TO: Mercedes-Benz Dealer Principals, General Managers, Sales	FROM: Gregory Gunther, Department Manager, Vehicle	
	Managers, Service Managers, Parts Managers	Compliance and Analysis, Engineering Services	
	RE: Emission Modification Notification - [[2020050028]]		
MY11-12 E350 BlueTec Update - Emission Modification		DATE: May 27, 2022	
	Category (EMC) #8

Campaign No. 2020050028, April 2022

SUBJECT: Model E-Class diesel vehicles (W212 platform)

Modification to the emission control system

Figure 1

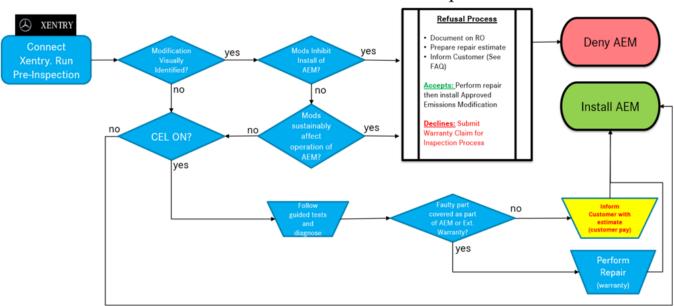
Note: goal of the pre-inspection process is to perform an inspection of the emission system and ensure all components are present and functioning correctly (Check engine light "CEL" ON/OFF). The pre-inspection consists of the following procedures as displayed in the below flowchart:

- **24. Visual inspection** of the emissions system to check for non-compliant alterations to the emission system that impedes the installation of the Approved Emission Modification (AEM) or substantially effects the operation of the AEM after installation. This consists of a brief visual inspection and does not require a technician to confirm if components are operating correctly. (Example: missing emission system components not replaced as part of the AEM)
 - 24.1 If an alteration has been found during the visual inspection that meet the criteria mentioned in point 1, please advise the customer these alterations must be reversed at their expense before to proceed with the AEM. Please follow the below process to submit a warranty claim for the time associated to diagnosis and provide an estimate to the customer.

Figure 7

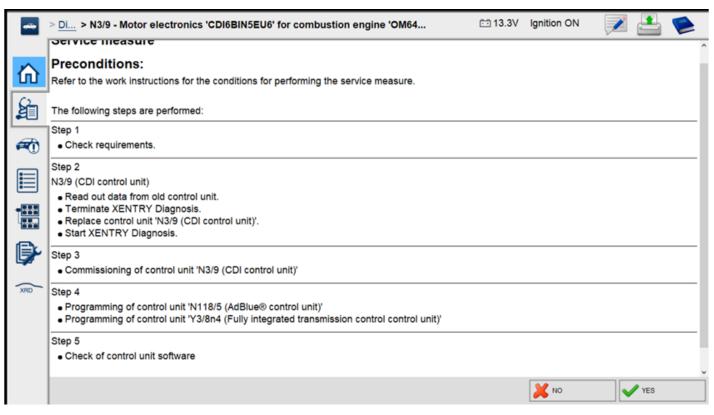
- 9. Replace both NOx sensors (A 642 905 11 00 85).
 - i For basic data, see AR14.40-P-2038OGE.
 - NOx sensor upstream of SCR catalyst (A 000 905 56 12 80)
 NOx sensor downstream of SCR catalyst (A 000 905 57 12 80).
 - $oxed{1}$ It is not necessary to perform the reset routine with XENTRY Diagnosis.
 - $oxed{1}$ The new sensors are already equipped with hot lubricating paste.
 - Li The wires on the old NOx sensors should be cut off to facilitate removal and to ensure that they are not reused (Figure 7).

Figure 8

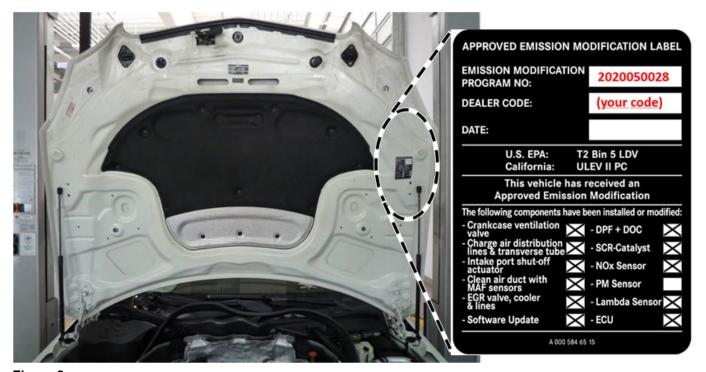
- 14. Clean the bonding surface area of the hood and apply the adhesive label (A 000 584 65 15) (Figure 8).
 - The fields on the label must be filled in accordingly. Please use black permanent marker. Refer to XENTRY procedure.
 - The adhesive label can be attached to the hood *during* the software update of the control units.
